**ADDENDUM NO. 1**  
**TENDER NO. 138-24**  
**DERWENT PARK CRICKET FIELD**

**January 15, 2025**

# CONTRACT DRAWINGS FOR DERWENT PARK CRICKET FIELD CITY OF WINDSOR

project no. 22-040  
drawing no. 22-040-02  
sheet no. 2 of 7  
scale AS SHOWN

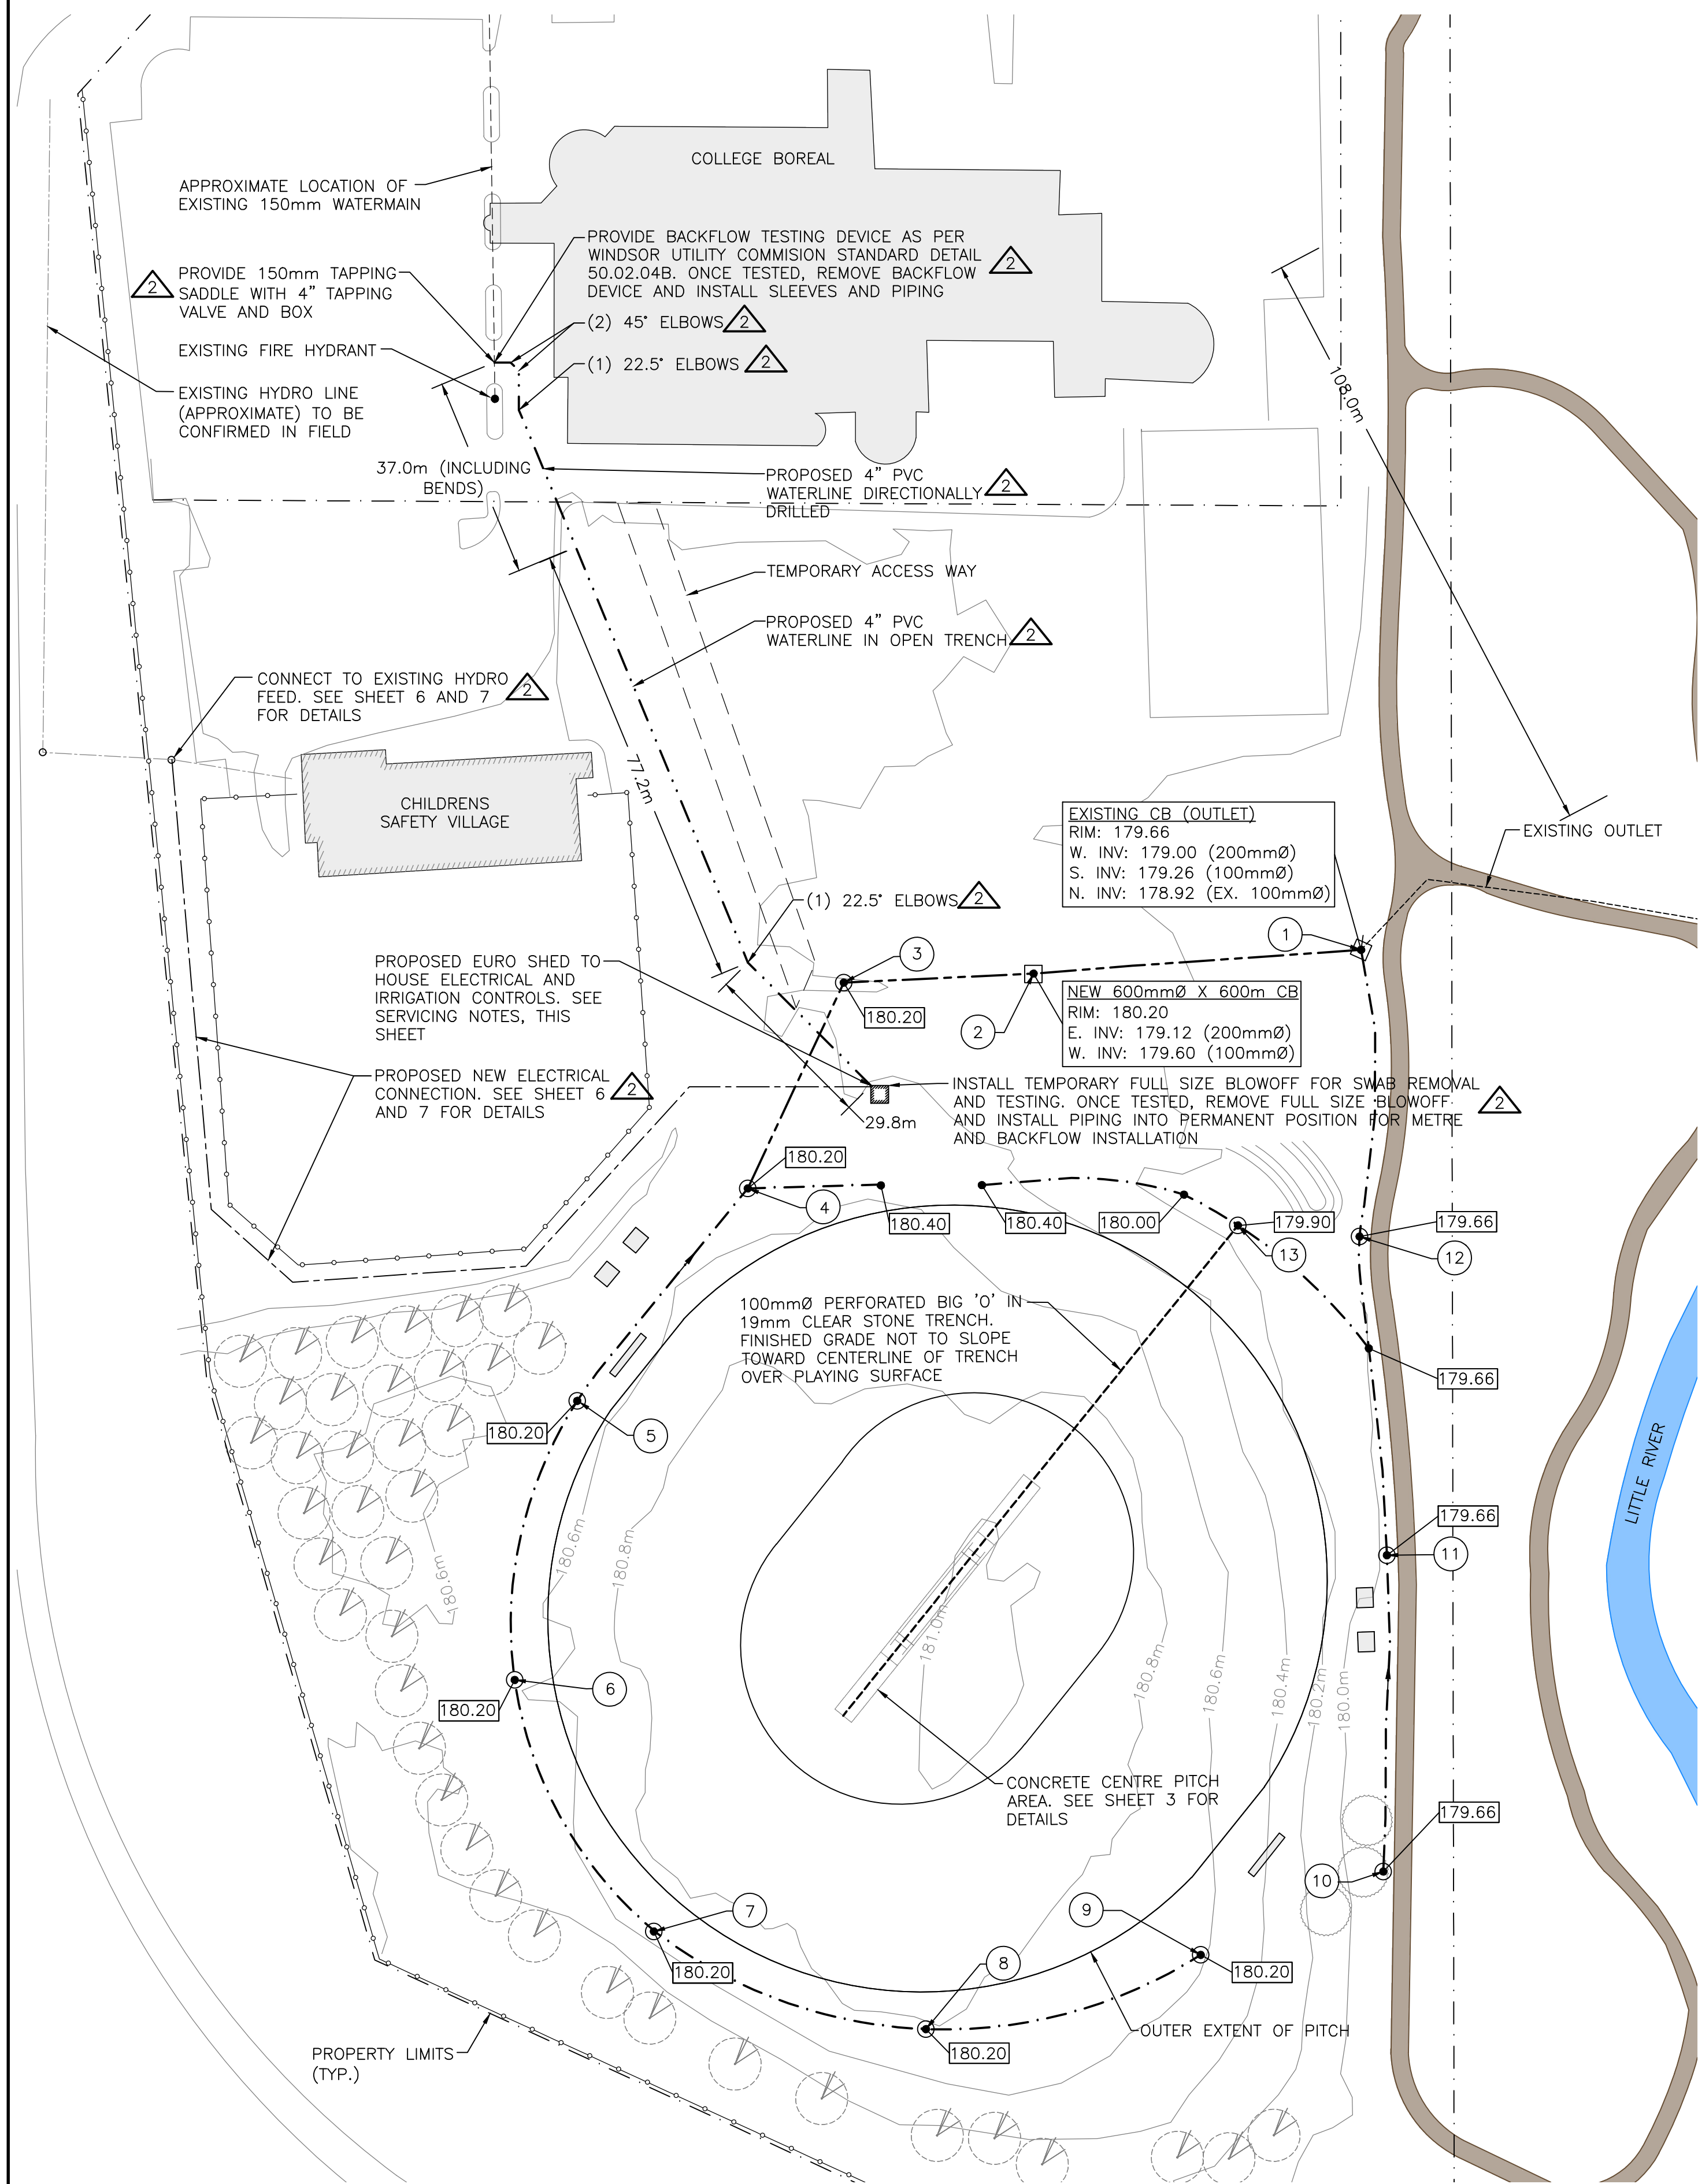
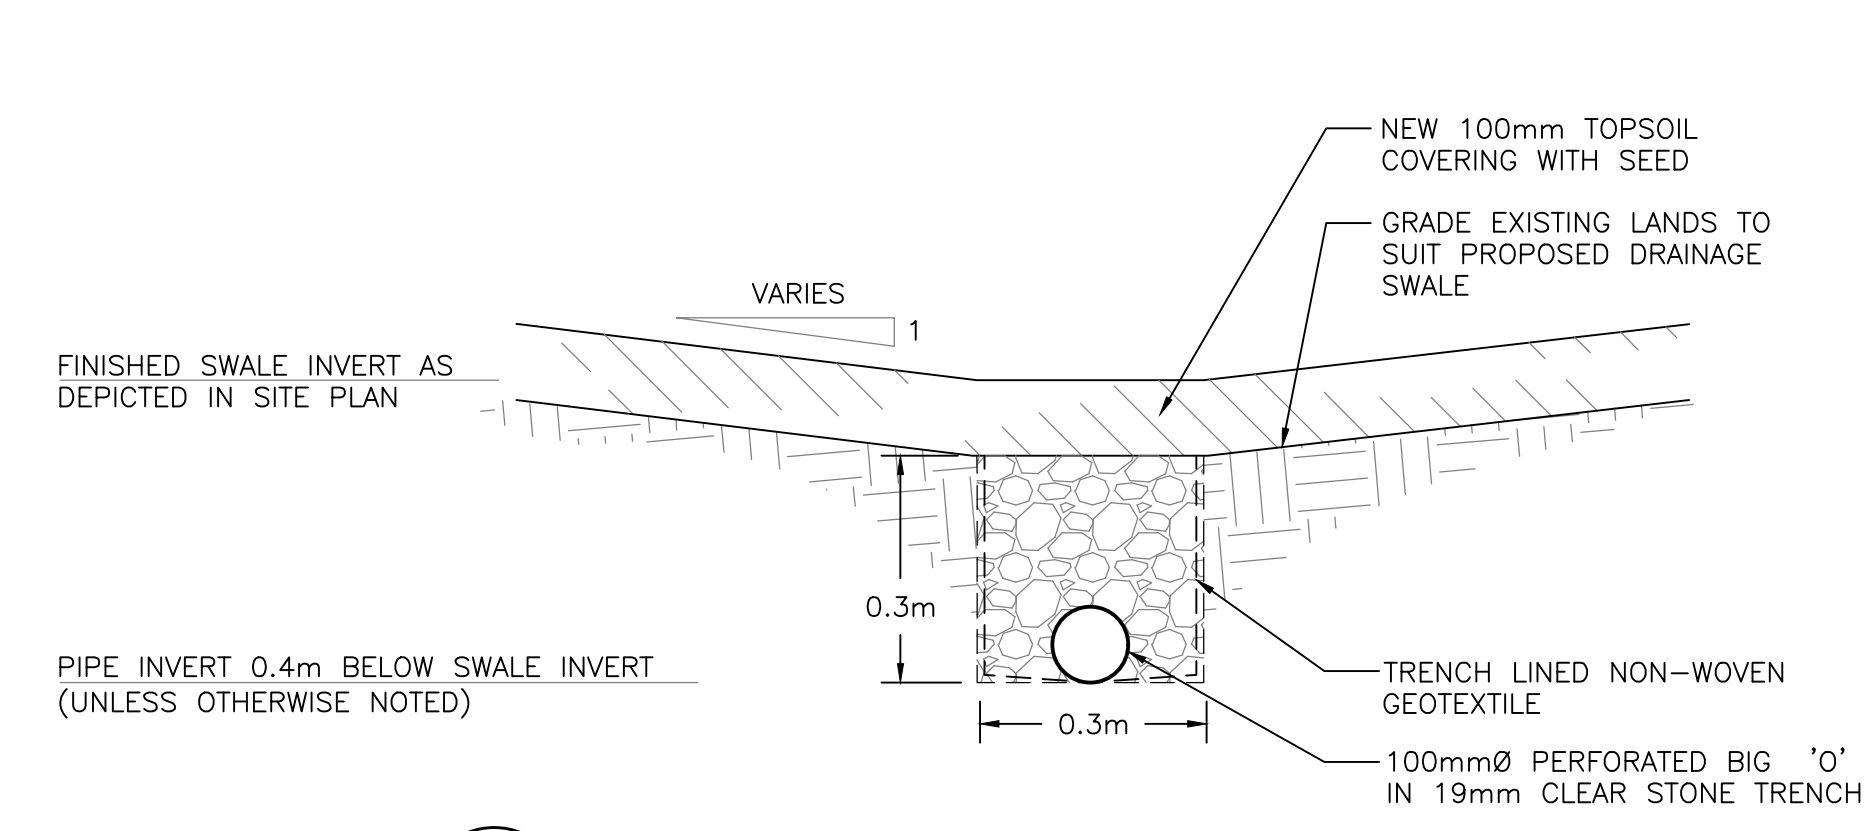
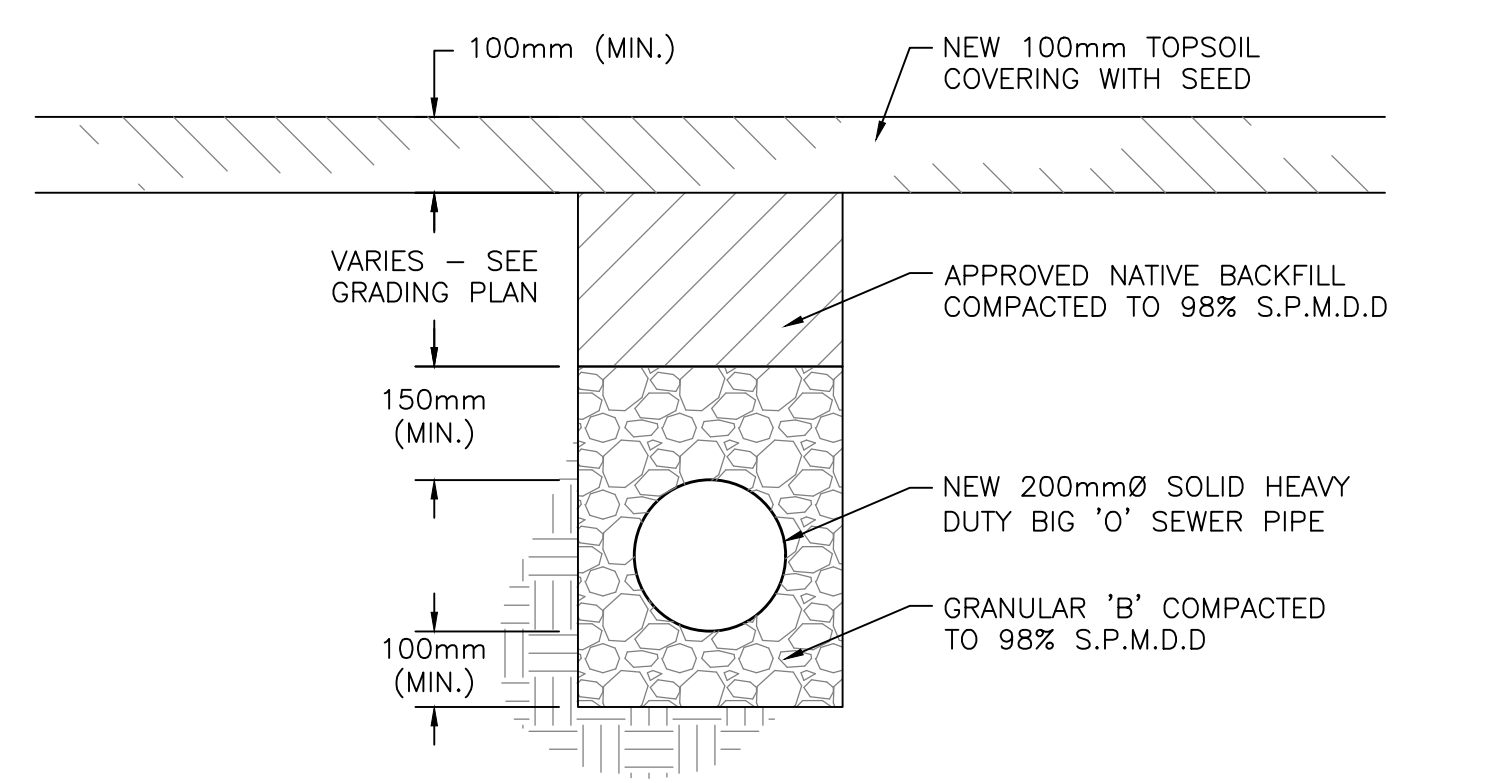
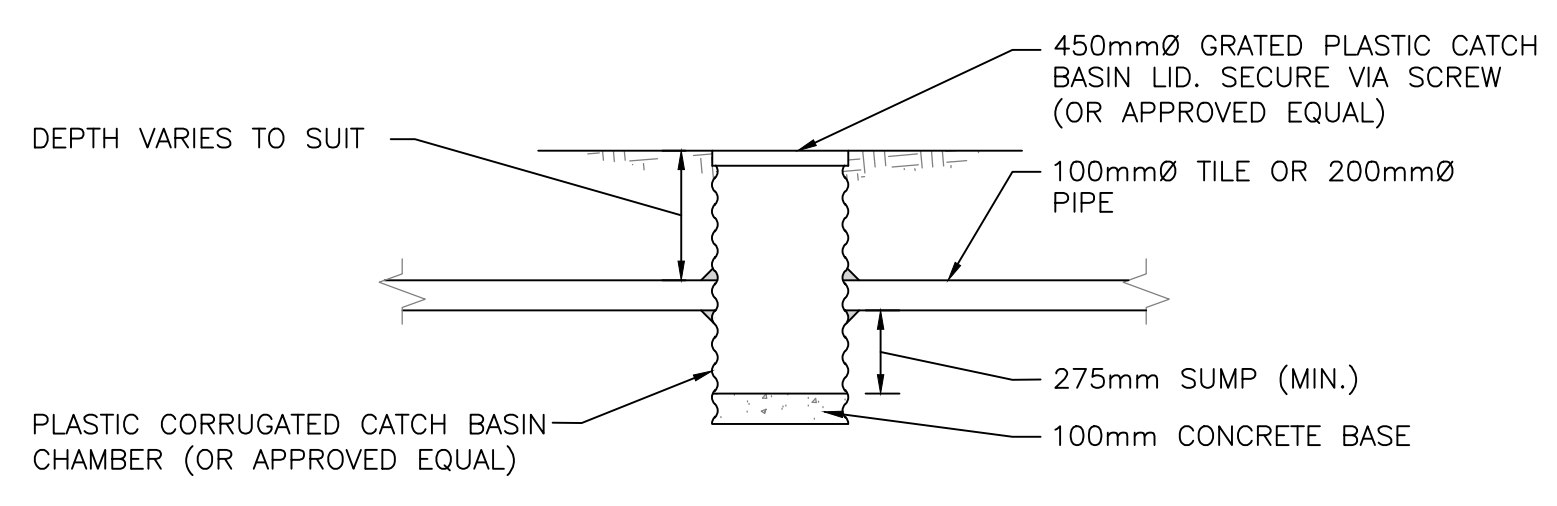
The Contractor shall also note that the proposed electrical conduit trench encircling the cricket field has been removed from the Contract. Drawing 22-040-02 has been amended to reflect this amendment.
